Access Compliance Report

Public Rights-of-Way

(Curb Ramps)

Intersection ID: 13572	Main Street: WINGATE_AV	Cross Street: MAYFAIR_AV	Location:	N
ADA ID: 005A1E355ECA	Ramp Type: PerpDiag	Initial Pass/Fail: Fail	Overall Compliance: No	Severity Score: 33.75
Codes/Mitigation Info/Possible Solution		Field Measurements/Component Compliance

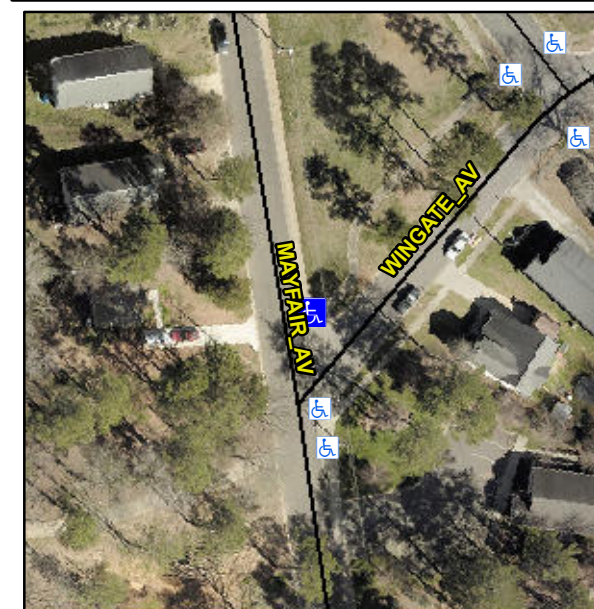
R304.5.1, R304.2.2

Remove & Replace Curb Ramp With Two New Directional Ramps or Equivalent.
